Access Compliance Report Public Rights-of-Way (Curb Ramps)

Main Street: NEWKIRK_RD		Cross Street: SAYBROOKE_LN		Location:	W
ADA ID: RPAT211104132859	Ramp Type: Type 4 - Parallel	Initial Pass/Fail: Fail	Overall Compliance: No	Severity Score:	30
Codes/Mitigation Info/Possible Solution			Field Measurements/Component Compliance

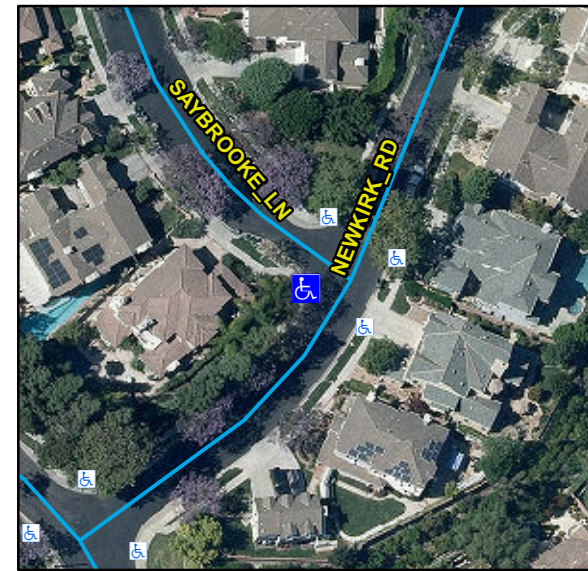
Compliance	Description	Data	Compliance	Description	Data
N/A	Ramp Length LT (in)	85	N/A	Ramp Length RT (in)	80
Yes	Ramp Width LT (in)	52	Yes	Ramp Width RT (in)	52
Yes	Ramp Run Slope LT (%)	1.9	No	Ramp Run Slope RT (%)	12.8
Yes	Ramp Cross Slope LT (%)	0.5	Yes	Ramp Cross Slope RT (%)	0.3
N/A	Landing Present	N/A	N/A	DWS Provided	N/A
N/A	Landing Length (in)	N/A	N/A	DWS Contrast	N/A
N/A	Landing Width (in)	N/A	N/A	DWS Length (in)	N/A
N/A	Landing Run Slope (%)	N/A	N/A	DWS Full Width	N/A
N/A	Landing Cross Slope (%)	N/A		DWS Offset Type	N/A
N/A	Landing Movement Obstructed?	N/A	N/A	DWS Offset Left (in)	N/A
	Landing Movement Type	N/A	N/A	DWS Offset Right (in)	N/A
N/A	Landing Shared	N/A			
N/A	Clear Space	Yes			
N/A	Clear Space To Crosswalk (in)	N/A			
N/A	Marked Crosswalk 1	No	N/A	Marked Crosswalk 2	No
	Crossing 1 Direction	SE		Crossing 2 Direction	NE
	Marked Crosswalk 1 Width (in)	N/A		Marked Crosswalk 2 Width (in)	N/A

Remove & Replace Curb Ramp With Two New Directional Ramps or Equivalent.

R204.3, R304.3.2, STD 1115
